EXHIBIT NO.	1
Application Number	5-08-251
Vicinity Map	
California Coastal Commission

EXHIBIT NO.	3
Application Number	5-08-251
Site Plan	
New High School	
California Coastal Commission

The following is a collection of quotes from the August 2008 DEIR that show the many flaws and inconsistencies that run throughout the published document. For the purposes of this response we are concentrating ONLY on the proposed athletic facilities which we feel as residents closely located to these proposed facilities, significantly impact us, as residents and as a neighborhood, the most substantially. By concentrating on this one issue, we are not indicating that we do not have other concerns about many other issues described in the DEIR related to SRHS #15 that we feel are important and that also affect our wellbeing. We support the efforts of other citizen groups who are responding to other serious issues.

Our organization, "Neighborhoods Organized and Involved to Support Education", is opposed to the building of SRHS #15 at the proposed site of Angel's Gate in San Pedro. These reasons are detailed in our response to the Draft Environmental Impact Response which is enclosed. Our objections

Figure 2-4
Conceptual Site Plan
Proposed South Region High School No. 15

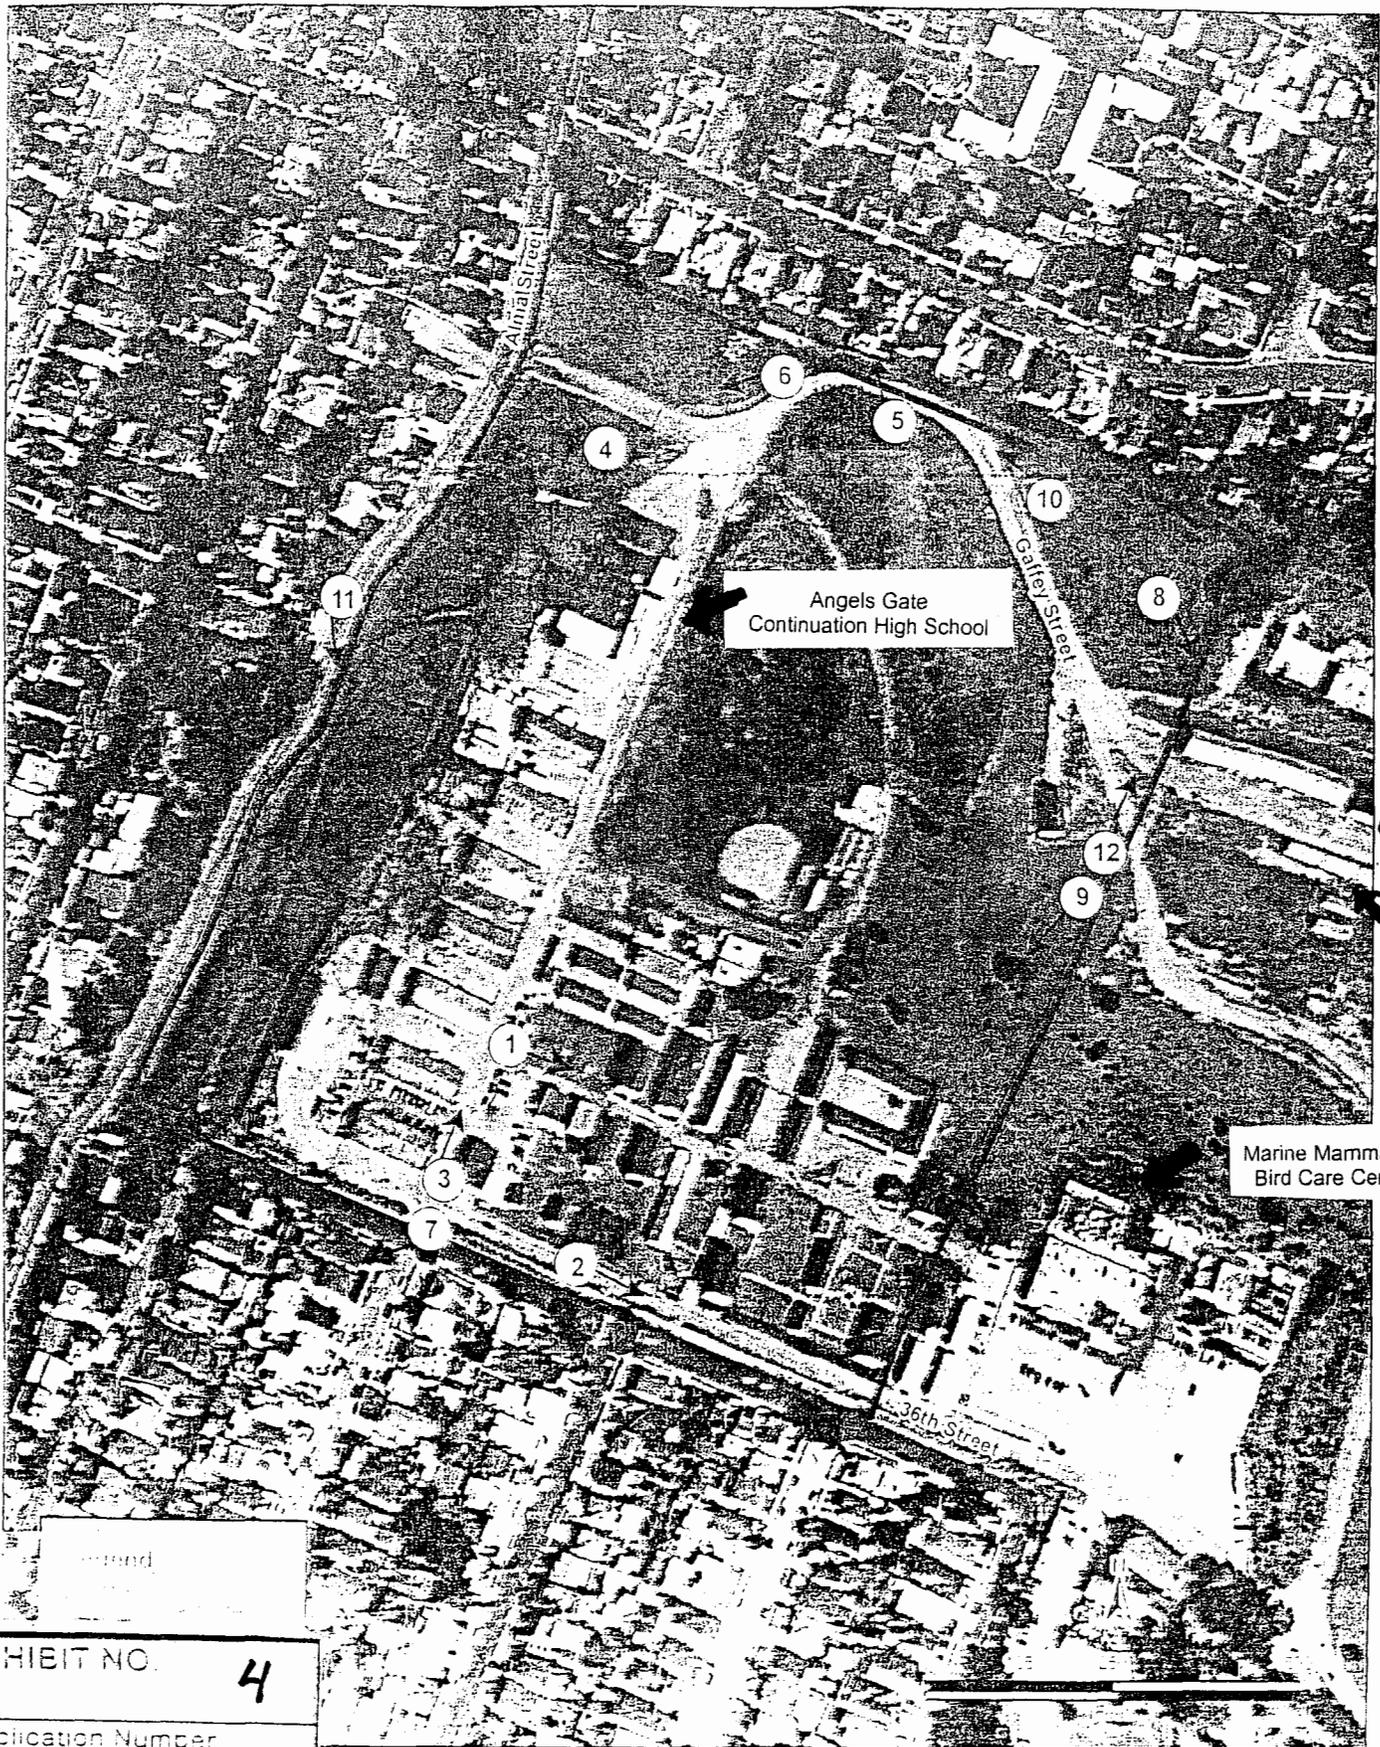
Figure 2-4 Conceptual Site Plan. The enclosed drawing of the proposed site is unmarked and confusing. It appears that the athletic facilities stretch along 36th Street within 100 feet of residences on 36th and below on Emily, Meyler, Parker and Cabrillo. It appears that a combination soccer/baseball turf field is closest to 36th Street. The location of the 200 seat bleachers is not illustrated. The athletic area appears to include four tennis courts, five basketball courts and a square with graph lines that may be a swimming pool. There is an arrow labeled “existing gate” that appears to be located at Meyler. There is parking at the far left but access to it is unclear. (See attachment)

- The Conceptual Site Plan (Figure 2-4) does not call out or identify the location of key elements described in the narrative, such as wind turbines, swimming pool, vehicular access points, pedestrian access, amphitheater, the two structures adjacent to Buildings E and F, landscaping concept, lunch shelters, etc. (Note: We've reviewed other LAUSD environmental documents and found that most provide detailed site plans, elevations, and cross-sections. We point out that Point Fermin Outdoor Education Center CEQA documents include detailed site plans, floor plans, and elevations.)

- The Conceptual Site Plan depicts several large polygons (shapes) but does not describe what they are. For example, there are several ovals of various sizes, cross-

- o Will the "Existing Building", depicted on the eastern perimeter of the site plan, be retained? If so, what function will it serve?
- o The exhibit appears to show the access road along the northern perimeter terminating at the property boundary. However, we understand that the road will provide secondary vehicle access from Gaffey Street. Please clarify by providing an exhibit and/or narrative on the use of the road.

- o We understand that up to 36 wind turbines "may" be incorporated into the project. The Conceptual Site Plan does not identify the location of these 50-foot high

- Page 3G-22, Bleacher Noise: Bleachers are not referenced in figure 2-4, the Conceptual Site Plan. Please explain how it was determined that a crowd cheers only 25 percent of the time. Please explain if there will be use of loudspeakers and announcers to add to the cheers of the crowd.

Figure 3A-2
Key Viewpoints
LAUSD South Region High School No. 15

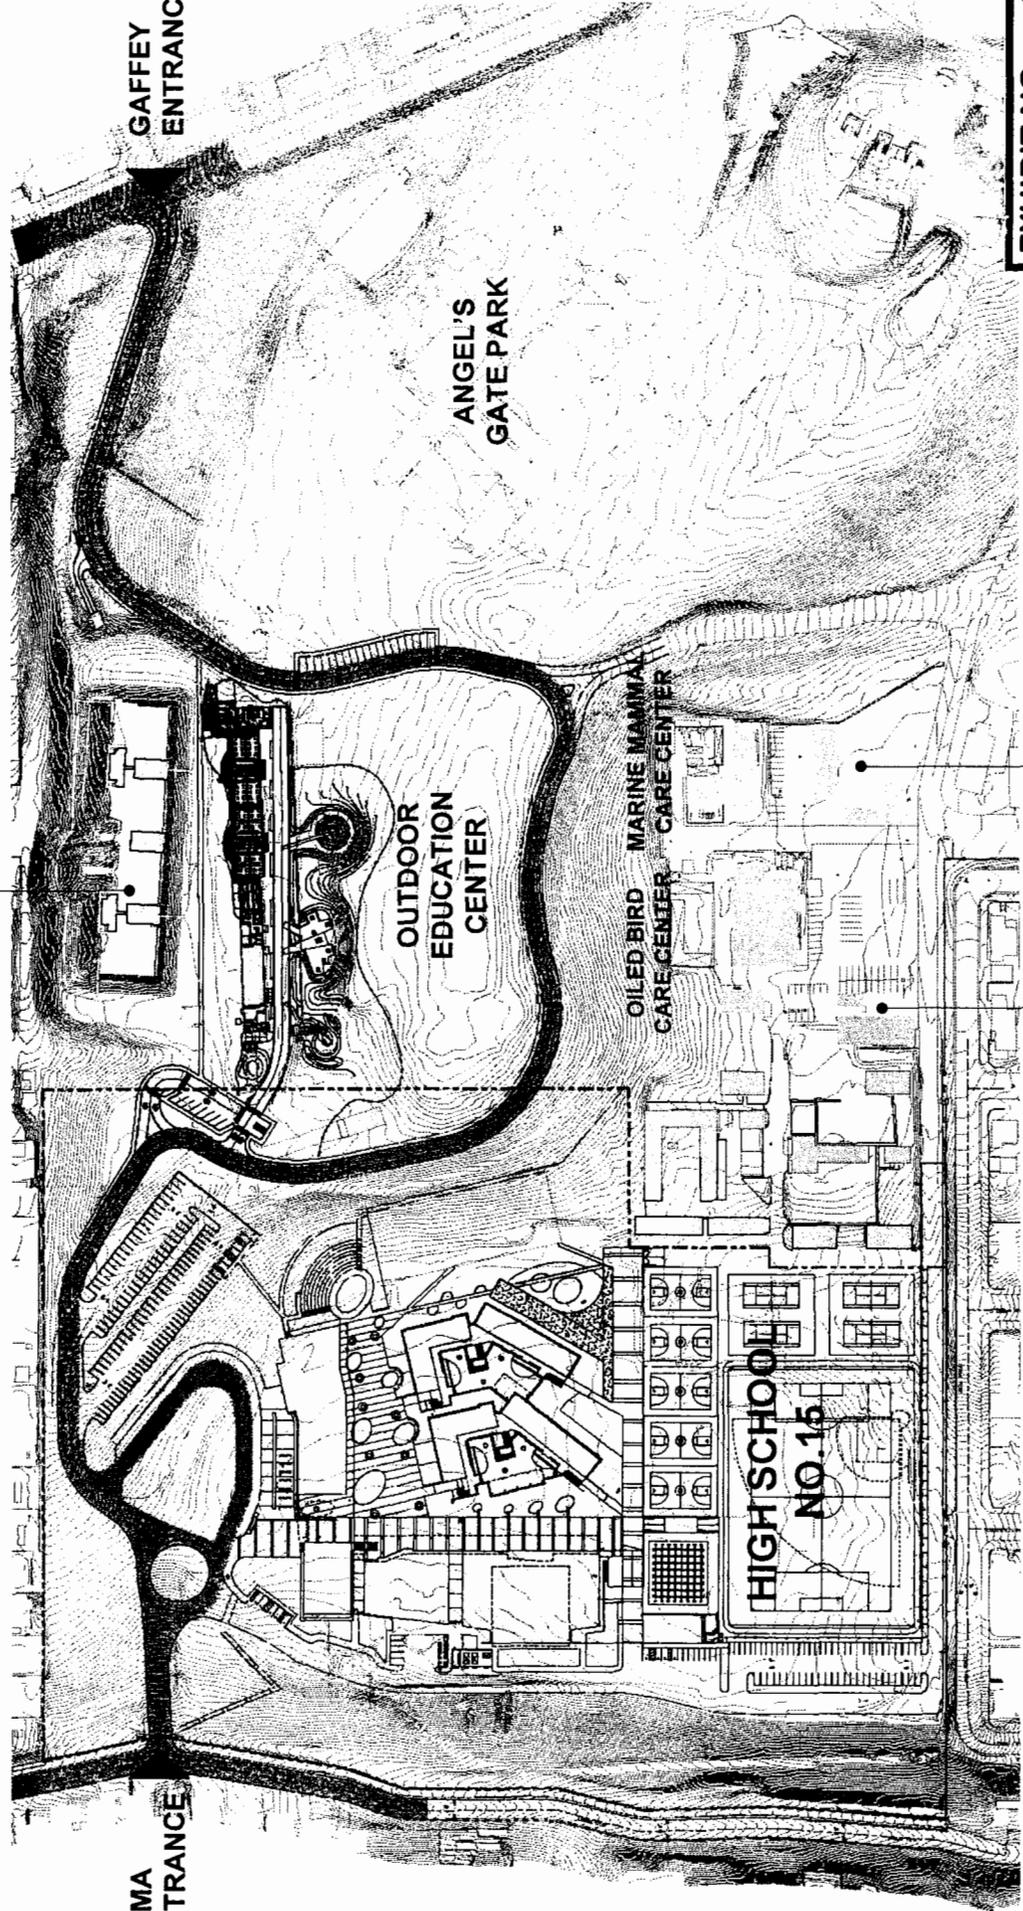
- Figure 3A-2, Key Viewpoints: The DEIR suggests that key viewpoints were chosen for their representation of the visual environment and viewer group locations. The selection of the key viewpoints gives little consideration of views to the site. We find this a major omission. We suggest that the following viewpoints be added: a viewpoint for the homes located at the

- Figure 3A-2, Key Viewpoints: The exhibit incorrectly labels an on-site road as Gaffey Street.
- Page 3A-5, Section 3A.3.3, Viewer Groups: Key Viewpoint 6 fails to adequately describe the visual impact the Proposed Project will have on the residents on Alma Street. To more appropriately describe the impact, a photograph should be taken from the front of their homes as they look up at the project, and then attempt to understand the enormous impact of several story buildings built close to the edge of the canyon. An attempt to illustrate what is there presently as to what is proposed is attached as Attachment 4. Further, the impact on residents on the east side of Almeria Street, from the intersection of 36th Street to 31st Street is totally disregarded. This should be discussed in detail as well: these residents will view the loading/receiving dock, trash enclosures, the back of the food service building and the gym.

Figure 2.4
Conceptual Site Plan
Proposed South Region High School No. 15
WITH MITIGATION FOR NOISE
& PARKING

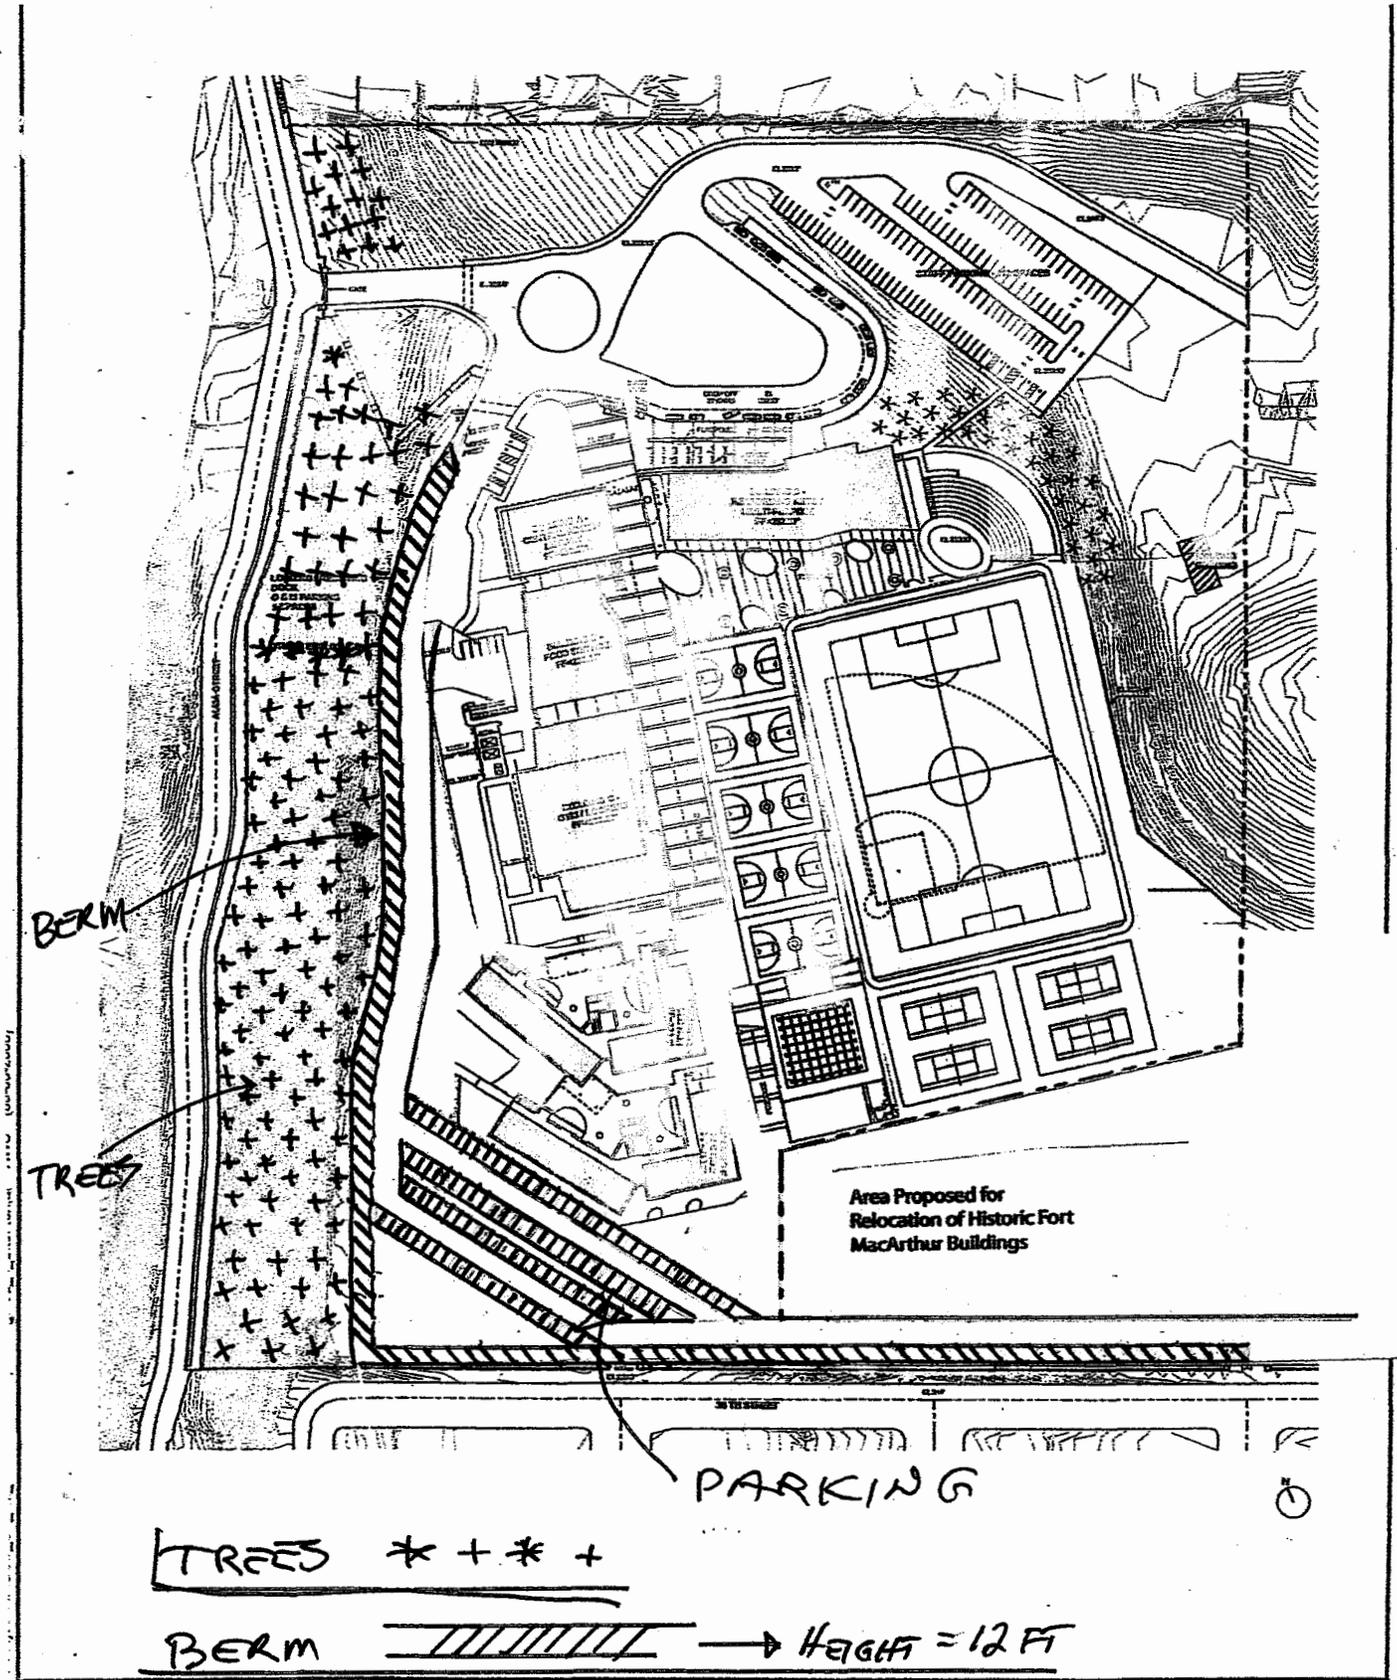
not good planning. All projected parking should be incorporated on the site. We suggest that LAUSD planners consider adding student parking on the large flat area to the east of the proposed faculty/staff parking lot or perhaps in the large vacant area adjacent to the drop-off area. We estimate these areas could accommodate an additional 100+ parking spaces. We suggest additional parking spaces instead of buildings.
